Technical Variance

TV No.	288309	Issue:	1	Date of Application:	15 Jan 2025
Application Type	One-off <input checked="" type="checkbox"/> Repeater <input type="checkbox"/>	Expiry date (If Repeater)	N/A		
Operator/Applicant	SAFRAN NACELLES / ROLLS-ROYCE DEUTSCHLAND	Original Request No.	2025-01-000652-1		
Engine Type	BR700-710	Engine Model	BR700-710A2-20		
Part Description	THRUST REVERSER UNIT (TRU)	Eng Serial No.	N/A		
Part No.	07G0001-017	Part Serial No.	LH1185		
Manual Title	CMM	Ref.	CMM-710-2BR	ATA Ref.	78-30-11
TV Title	OSD 62593 – THRUST REVERSER PIVOT DOOR LATERAL FRAME DELAMINATED				
Hours	4443	Cycles	1370

This repair instruction gives the procedure to repair the lateral frame on the upper pivoting door.

Figure 1: Details of the damage

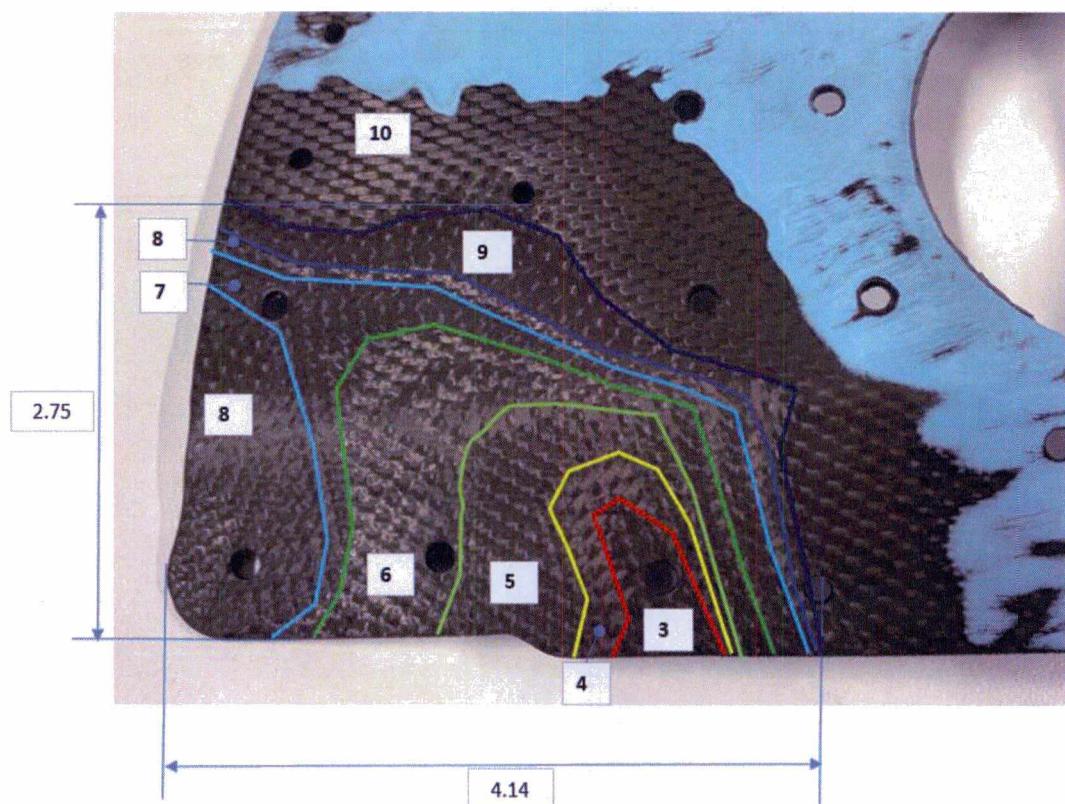
During removal of the pivot door corner angle of the subject Left Hand (LH) TRU, delamination has been found on the inboard lateral frame of upper pivoting door. Refer to Figure 1 for damage details.

Areas with different plies number remaining are shown below.
The number given is the number of remaining plies: 1 ply = .011 inch thick.

2. Do an inspection.	Refer to Figure 1. Make sure that the condition is the same as reported. If not, then contact RRD OSD.
3. Smooth the damage	Refer to Figure 1. If necessary, to facilitate the carbon plies filling shape and installation, lightly smooth the carbon plies to obtain regular shape. Make sure to remove the minimum quantity of material, do not increase the final size of the damage or the deepest area.

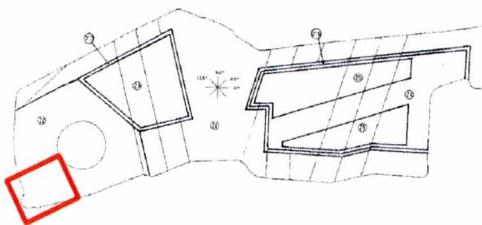
Per Ref [1] page C1-3 (29/64), the lateral frame is made of 10 carbon plies in damage area (zone Z2) (see picture below)
